# NORTHEAST UTILITIES

Millstone Nuclear Power Station, Unit No. 3  
Response to Materials Engineering Branch DSER Open Items

Millstone Nuclear Power Station, Unit No. 3

MTEB 251.1 Appendix G and H, 10CFR50 (Draft SER Section 5.3.2)

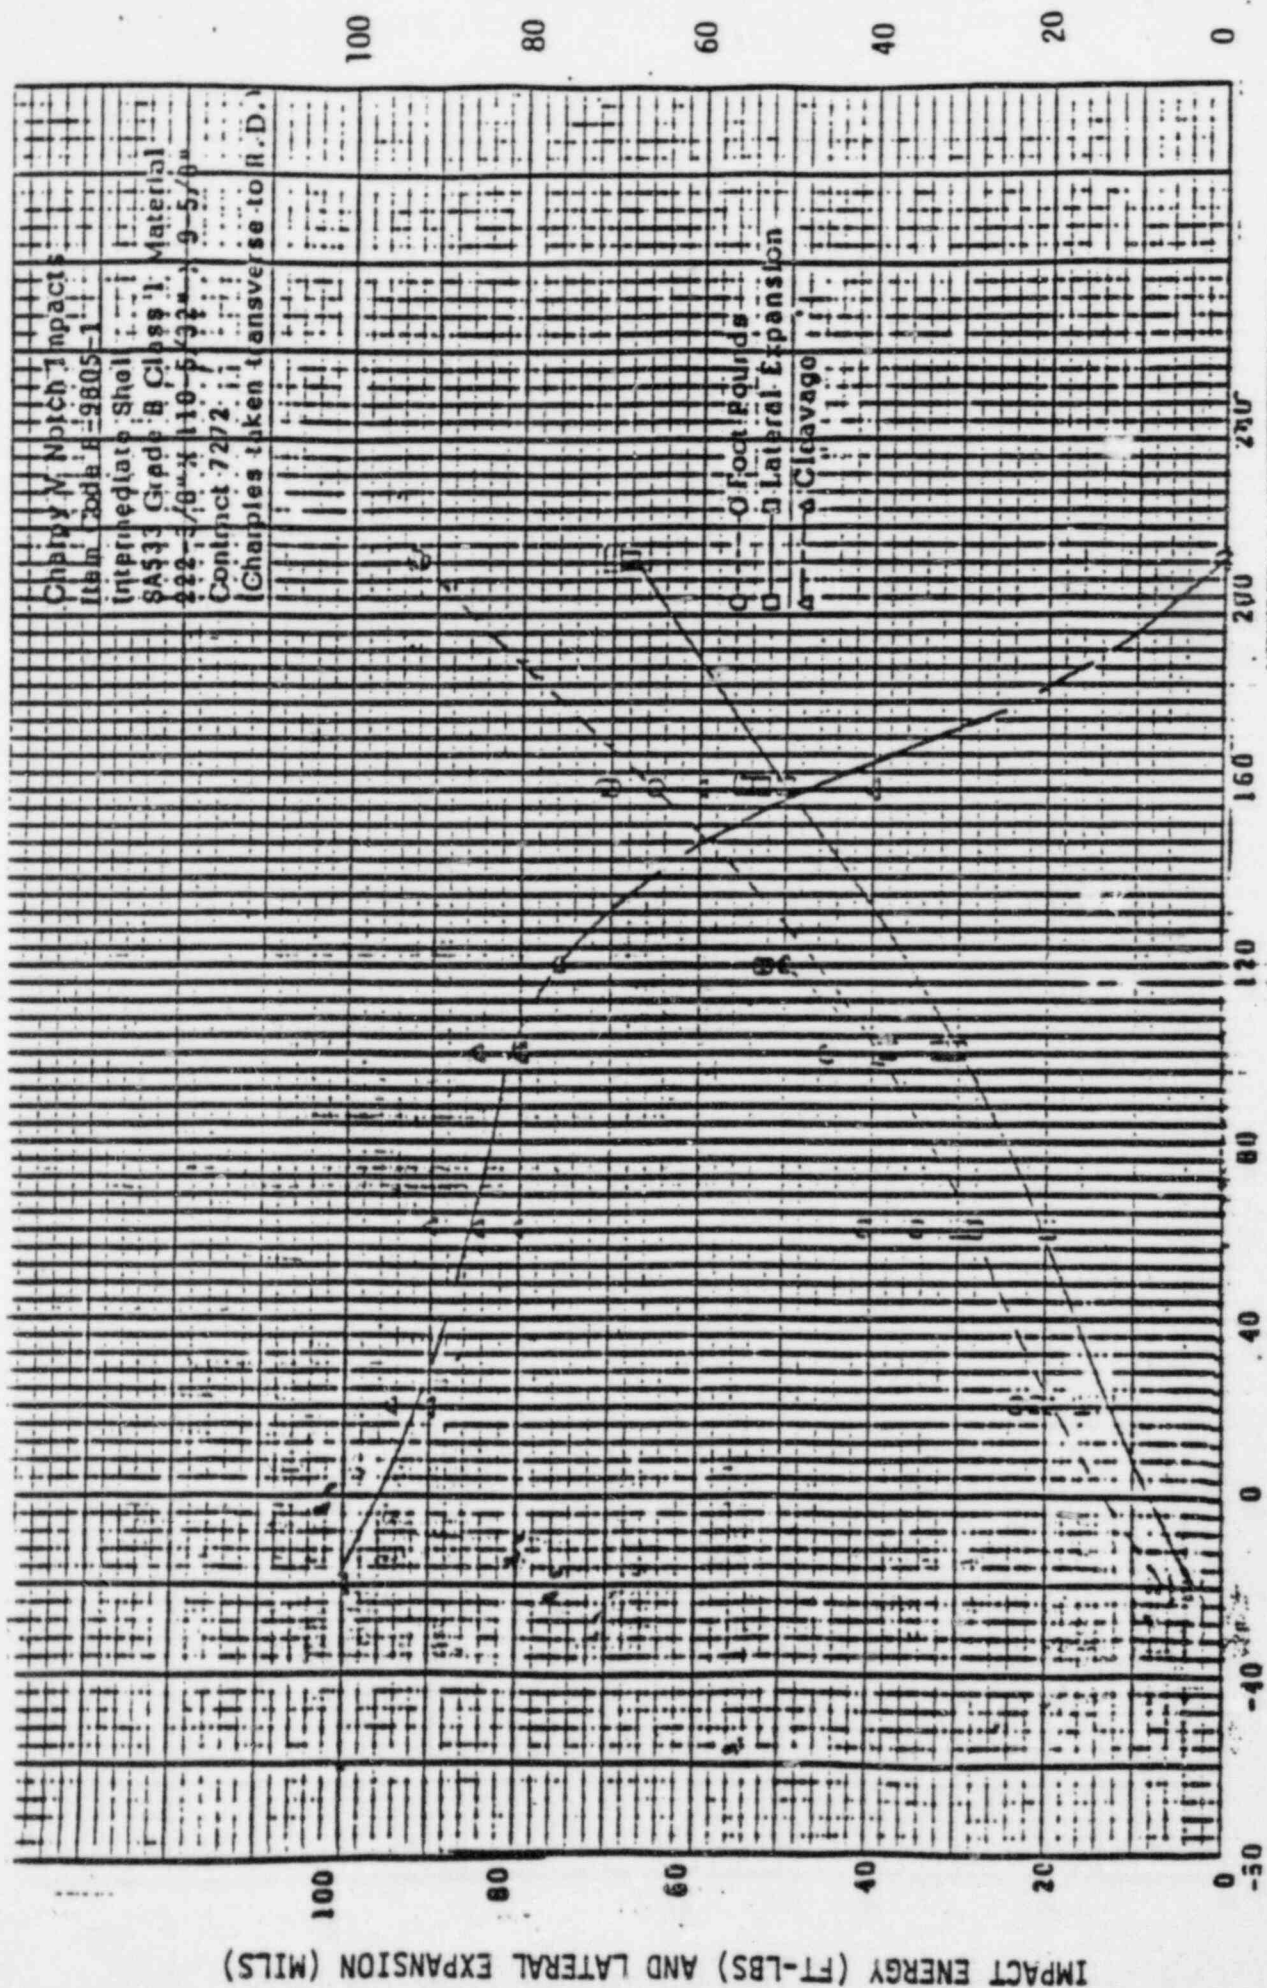
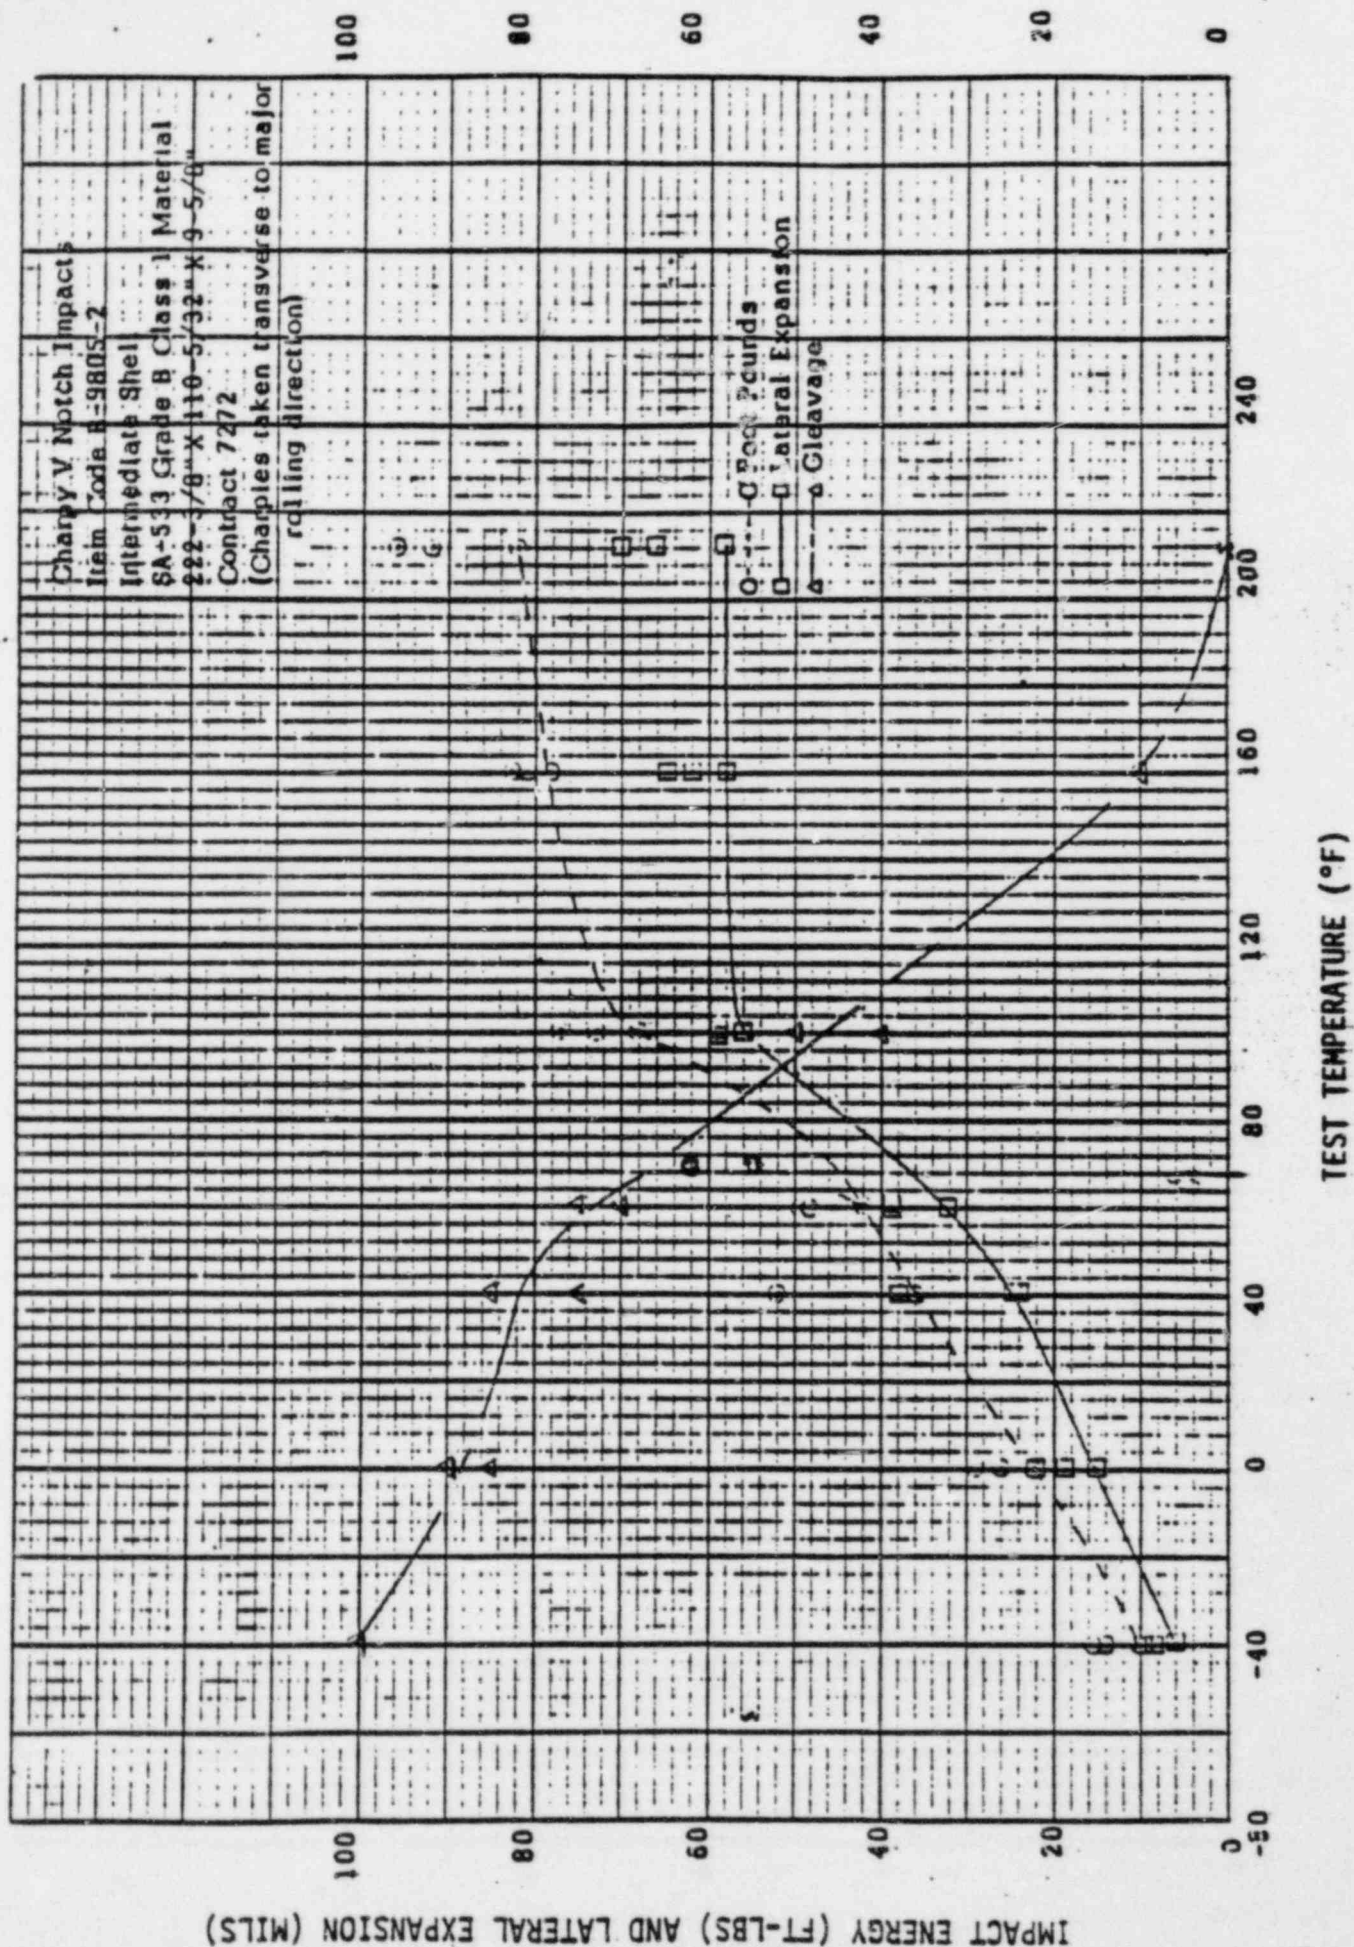
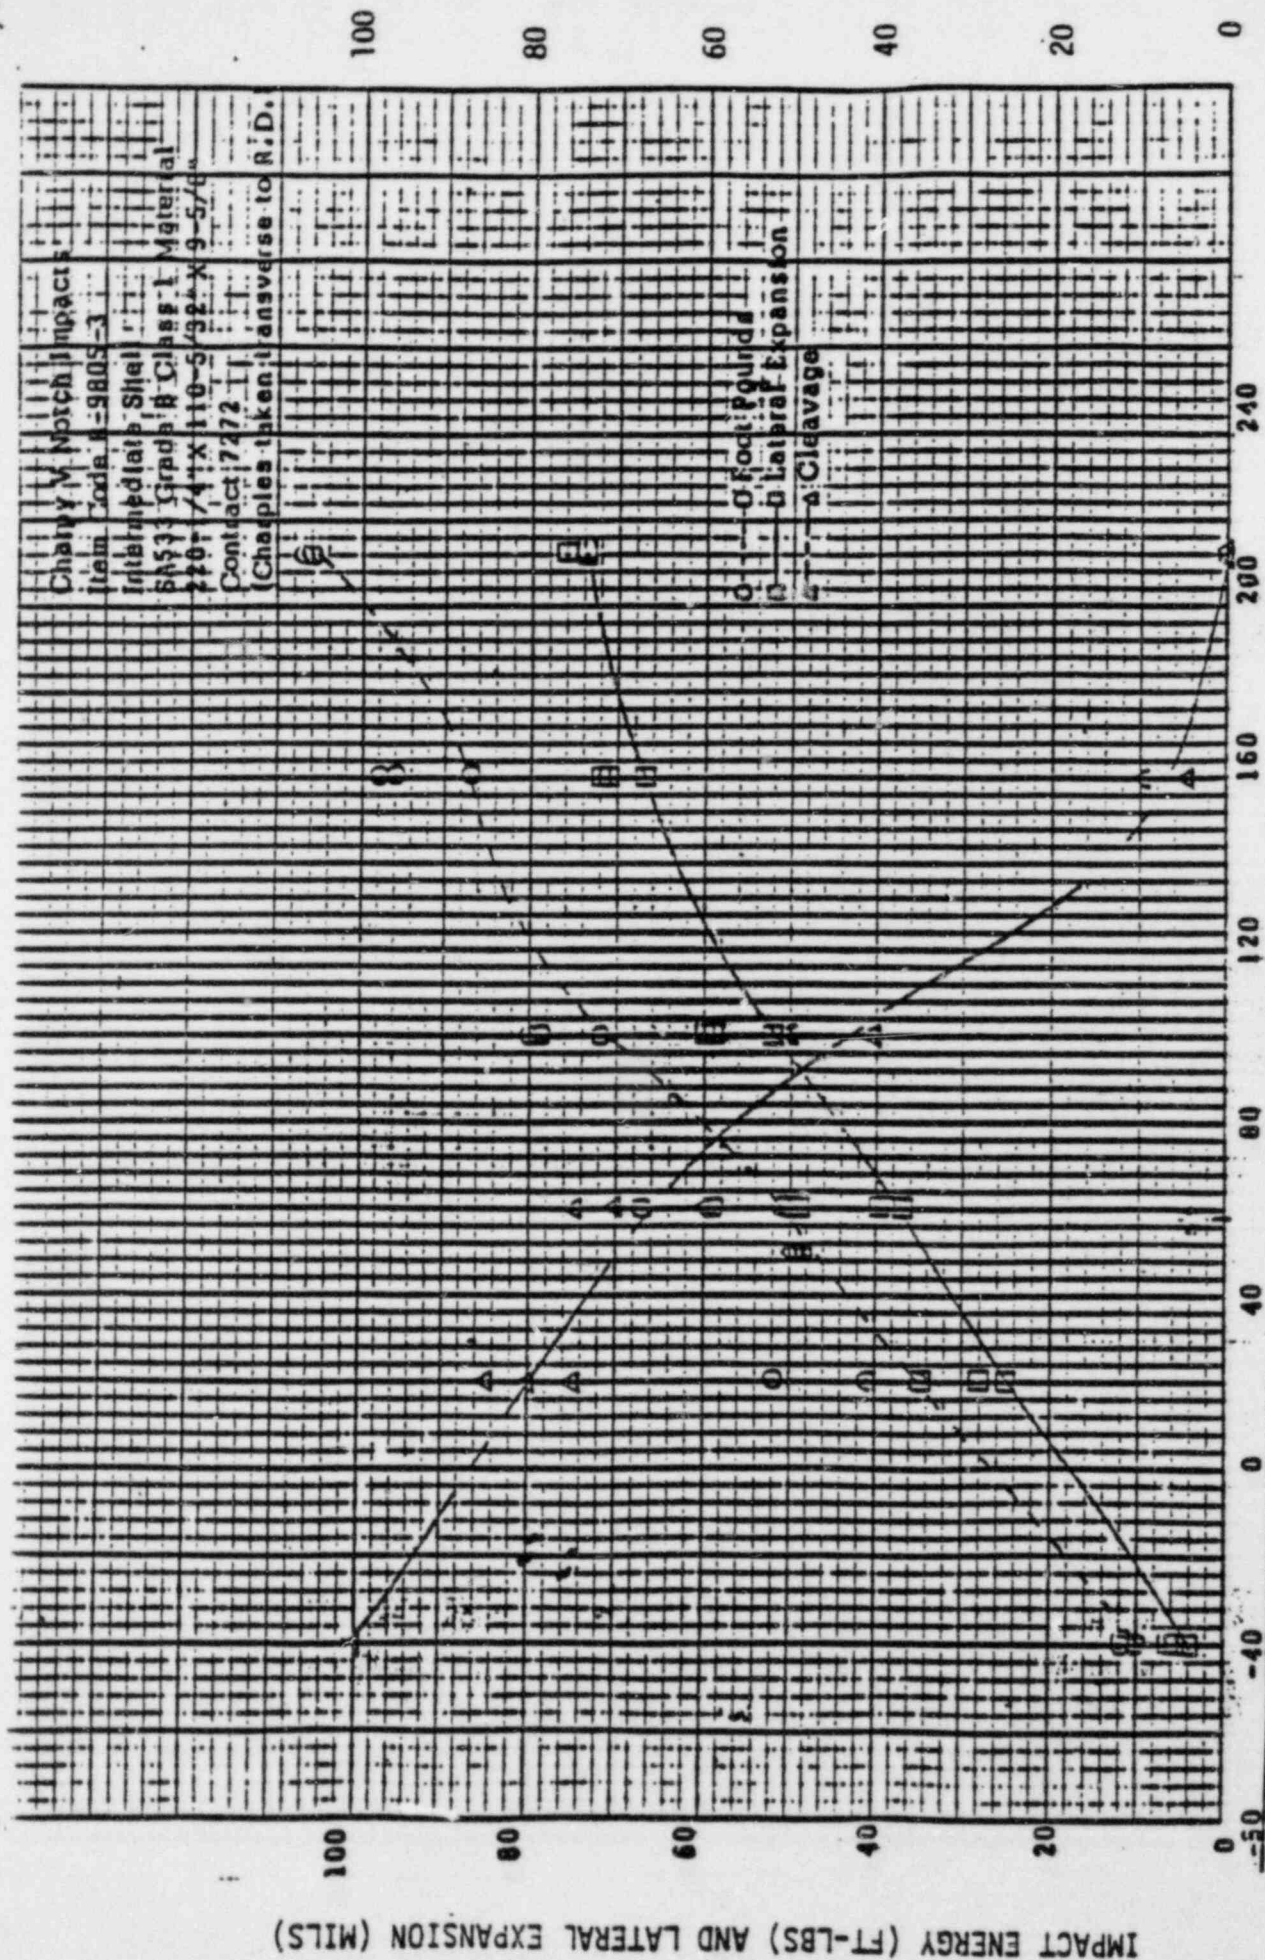
- a. Provide full Charpy V-notch curves for the reactor beltline materials. The curves should be in terms of fracture energy (ft-lbs) and lateral expansion (mils) versus test temperature (°F).
- b. Indicate the base and weld materials in the surveillance capsules. The identification should include the following:
  - (1) Chemical composition
  - (2) Heat treatment
  - (3) Plate number for base materials and weld control number for weld materials.
- c. Indicate the lead factors for all the surveillance capsules and their azimuthal positions within the reactor pressure vessel.
- d. Provide technical justification for the surveillance capsule withdrawal schedule as outlined in Section 5.3.1.6 of the Millstone Nuclear Power Station, Unit No. 3 FSAR.
- e. Provide pressure-temperature limits for the Millstone Nuclear Power Station, Unit No. 3 reactor vessel.

- Part (a) Please find attached (Figures 1 through 7) the Charpy V-notch curves for the Millstone Unit No. 3 reactor beltline materials. These curves originate from Combustion Engineering test data.
- (b) Intermediate shell plate B9805-1, Lukens heat no. C4039-2 is the surveillance base material. The chemical composition (C-E analysis) and heat treatment of plate B9805-1 is given in Table 1.
